APPEAL	SUMMARY
,	00111111 1111

Appeal ID: 18977	Project Address: 901 SW King Ave
Hearing Date: 2/13/19	Appellant Name: Dave Bateman
Case No.: B-001	Appellant Phone: 503-227-1171
Appeal Type: Building	Plans Examiner/Inspector: Preliminary
Project Type: commercial	Stories: 12 Occupancy: R-2 Construction Type: 1-A
Building/Business Name: Celio Apartments	Fire Sprinklers: No
Appeal Involves: Alteration of an existing structure	LUR or Permit Application No.:
Plan Submitted Option: pdf [File 1] [File 2]	Proposed use: Apartment Building

# Appeal item 1

#### Alternate Type 13 sprinkler, standpipe and fire pump system: Granted as proposed.

Typical floor plan

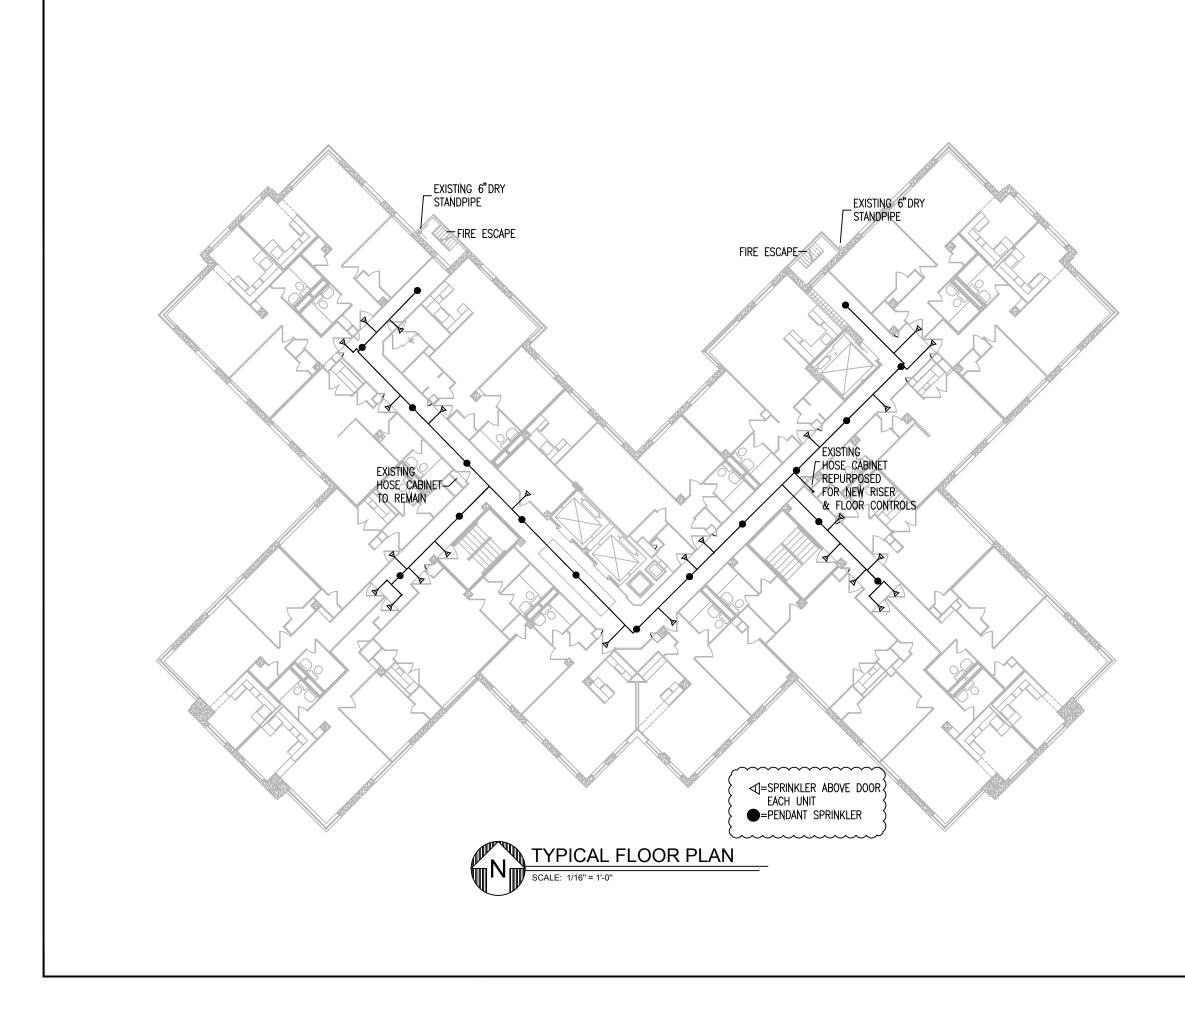
Viking proposes that this building is equipped with new automatic sprinkler systems. A new 6" fire service will be installed supplied by a single main in King St. A double-check valve assembly will be installed at the property line and equipped with a Fire Department Connection located on King St installed in a visible and accessible location in accordance with NFPA 13. Fire Department Connection will be equipped with signage indicating the fire pump design requirements.

The 6" fire service will terminate in the existing mechanical room in the basement. A single electric fire pump with Automatic Transfer Switch will be installed to provide sprinkler system demand. The fire pump system will be installed in accordance with NFPA 20 and include a jockey make-up pump, a metered test loop and test header, and an automatic city bypass.

Each level of the building will be provided with a zoned floor control assembly in accordance with NFPA 13 for multi-story buildings. Viking proposes that one of the existing Class II hose cabinets per floor be converted for the use of the floor riser assembly connected to a sprinkler riser supplied by the fire pump system.

The sprinkler riser will supply wet sprinkler systems at every occupied level (Bmst-12). Floors 1-12 will be provided with a partial "life safety" arrangement per NFPA 101 31.3.5.9 (2006ed). Fire sprinklers will be provided in the corridors spaced in accordance with NFPA 13. A single fire sprinkler will be provided within each dwelling unit located above the unit doorway. The system to be hydraulically calculated using the "Room Design Method" (most remote 5 heads in the corridor per NFPA 13 11.2.3.3.6). All piping proposed in this project to be sized to accommodate future sprinkler expansion.

Common and utility areas on Bsmt and Level 1 to be equipped with fire sprinkler systems designed to the appropriate hazard per NFPA 13. The intent of this project is to completely protect the building with fire sprinklers with the exception of within each unit beyond the single head described.

Existing dry standpipes to remain.

This proposed system will provide a fully automatic life safety sprinkler system for all tenant-occupied floors. The existing dry standpipes, and one of the existing Class II hose cabinets will provide responding fire department personnel with functionality similar to a Class III standpipe system.

All components will be installed to the appropriate NFPA standards. Future conversion to 100% sprinkler coverage will require no rework of piping or equipment installed under this proposal.

Installation of a fully conforming system is cost prohibitive and will not be undertaken as a voluntary upgrade. This proposal provides substantial improvement in the life-safety protection of this building.

The Administrative Appeal Board finds that the information submitted by the appellant demonstrates that the approved modifications or alternate methods are consistent with the intent of the code; do not lessen health, safety, accessibility, life, fire safety or structural requirements; and that special conditions unique to this project make strict application of those code sections impractical.
